SERVICE BULLETIN

DATE: 13 APRIL 2006

TAILBOOM ASSEMBLY ATTACH FITTING ONE TIME INSPECTION, ATTACH FITTING AND NUTPLATE REPLACEMENT

Model 600N Helicopters, serial number RN003 thru RN058 that have not been modified by TB600N-007, or latest revision.

Figure 1. Attach Point Access

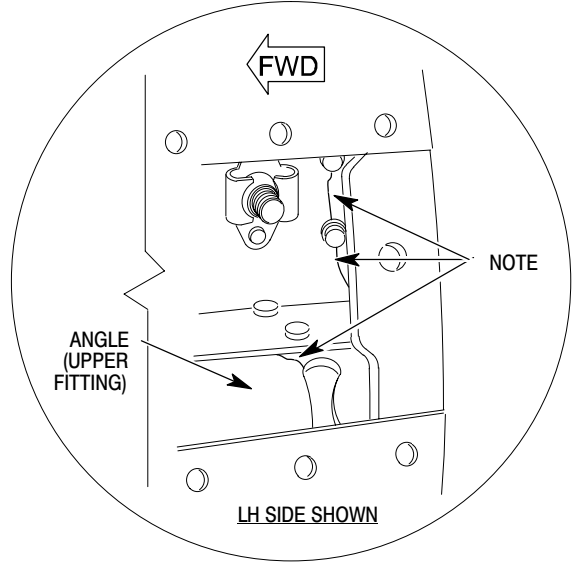
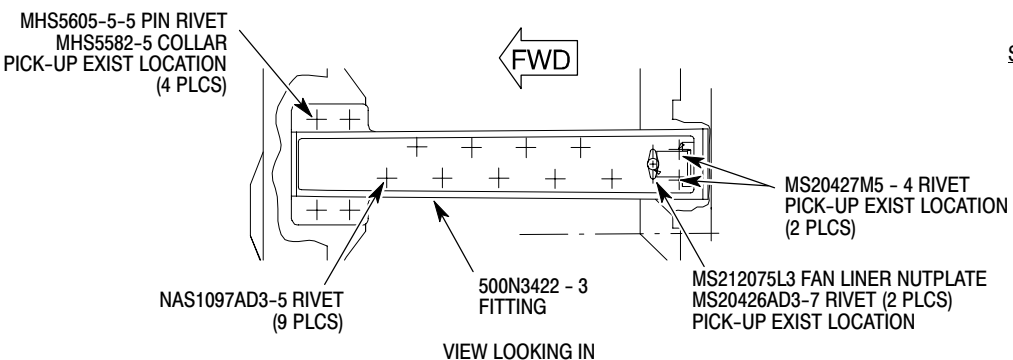
- (4). Remove button plugs from all four attach points.
- (5). Remove covers over all four, upper and lower, tailboom attach points.
- (6). Remove tailboom attach nutplates.
- (7). Thoroughly clean attach fittings.
- (8). Using bright light and 10x magnifying glass, visually inspect for cracks in attach fittings and upper angle (Ref. Figure 1).

NOTE:
AREAS WHERE CRACKS ARE MOST LIKELY TO APPEAR.

- (9). Using a magnet, check top-right attach fitting. If it is steel, attach fitting does not need to be replaced and proceed to step (10). If attach fitting is aluminum, proceed as follows.

- (a). Remove anti-torque fan (Ref. CSP-HMI-2, Sec. 64-25-30, Anti-Torque Fan Removal).
- (b). Remove anti-torque fan liner (Ref. CSP-HMI-2, Sec. 64-25-30, Anti-Torque Fan Liner (Felt Metal Seal) Removal).
- (c). Remove rivets and remove and retain outer ring frame upper skin.
- (d). Remove rivets and remove and retain RH outer ring frame lower skin.
- (e). Remove and retain fan liner nutplate.
- (f). Remove rivets and remove and discard RH upper attach fitting.
- (g). Position new 500N3422-3 attach fitting between aft ring frame and fan support frame and securely clamp in place.
- (h). Mark location for all rivet holes and fan liner bolt hole on attach fitting.
- (i). Backdrill tailboom attach bolt hole, 0.315-0.322 in. (8.001-8.1788 mm), and nutplate rivet holes.
- (j). Remove attach fitting.

- (k). Drill rivet holes and fan liner bolt hole in new attach fitting using drill press.
- (l). Deburr holes and remove all debris.
- (m). Temporarily install attach fitting with clecos.

- (n). Install rivets securing attach fitting in place.
- (o). Install fan liner nutplate.
- (p). Install RH outer ring frame lower skin.
- (q). Install outer ring frame upper skin.
- (r). Install anti-torque fan liner (Ref. CSP-HMI-2, Sec. 64-25-30, Anti-Torque Fan Liner (Felt Metal Seal) Installation).
- (s). Install anti-torque fan (Ref. CSP-HMI-2, Sec. 64-25-30, Anti-Torque Fan Installation).
